Addendum No. 2
February 24, 2017

Project: Brandon Valley Middle School Office Addition & Remodel
Brandon, South Dakota

Project No.: 2700

1 FOOTING AND FOUNDATION PLAN - AREA A
 SSD-1 1/8" = 1'-0"

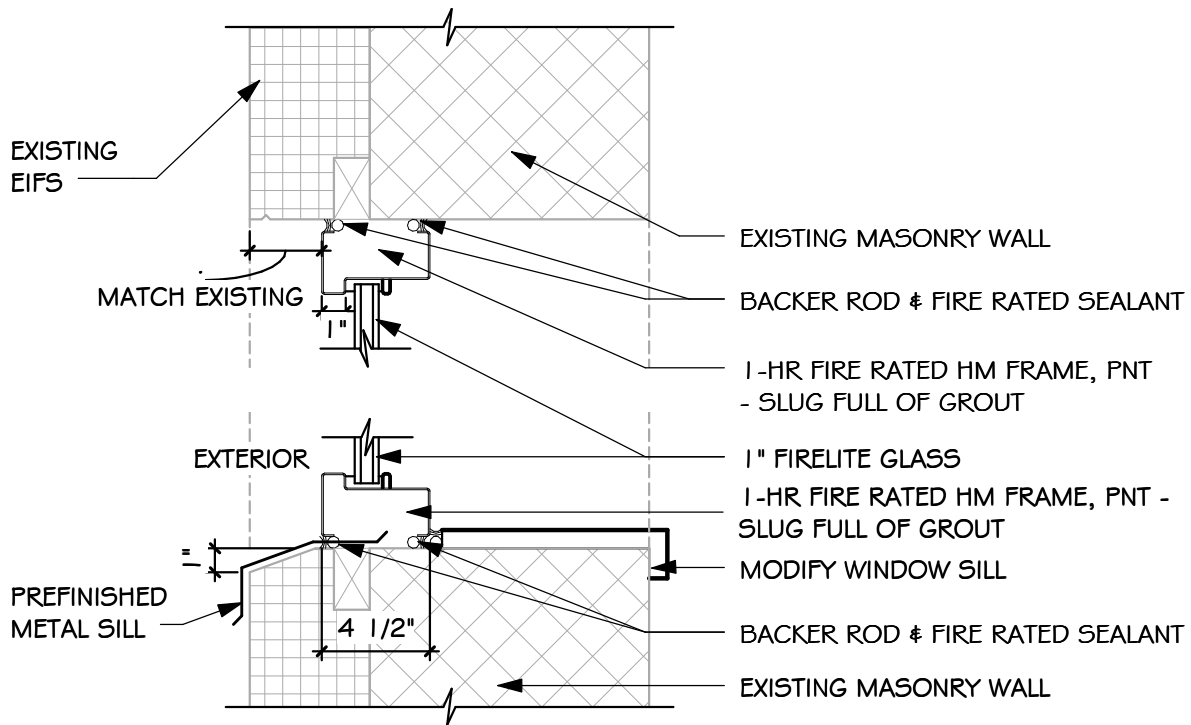
6) DRAWING SHEET 3.1-1

- a) Refer to Structural Supplemental Drawing SSD-1, attached to the end of this addendum, for revised location of foundation wall at south side of Vestibule 100.

SD-11

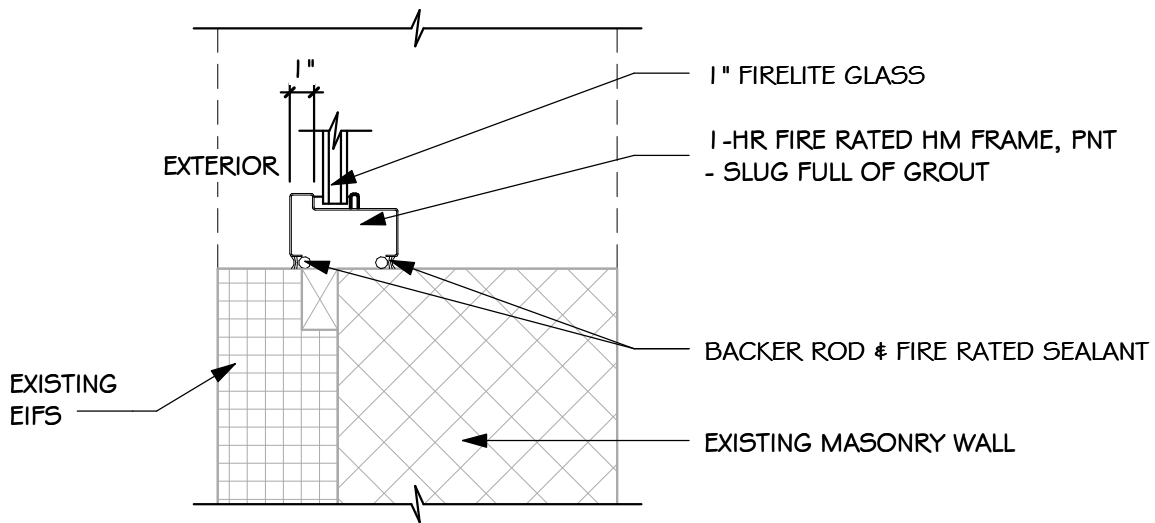
8) DRAWING SHEET 4.00

- a) Remove and replace 5 existing clerestory windows at east wall of Commons 121 with 1-hour rated, single rabbet hollow metal frames and 1" Fire-Protection-Rated-Insulated Glazing. Refer to Supplemental Drawing SD-11, attached to the end of this addendum, for head, jamb and sill details at these windows. Paint hollow metal frame to match color of existing aluminum framing. Modify existing window sills as required to accommodate thicker frame and patch existing EIFS as required at perimeter of opening after window installation.
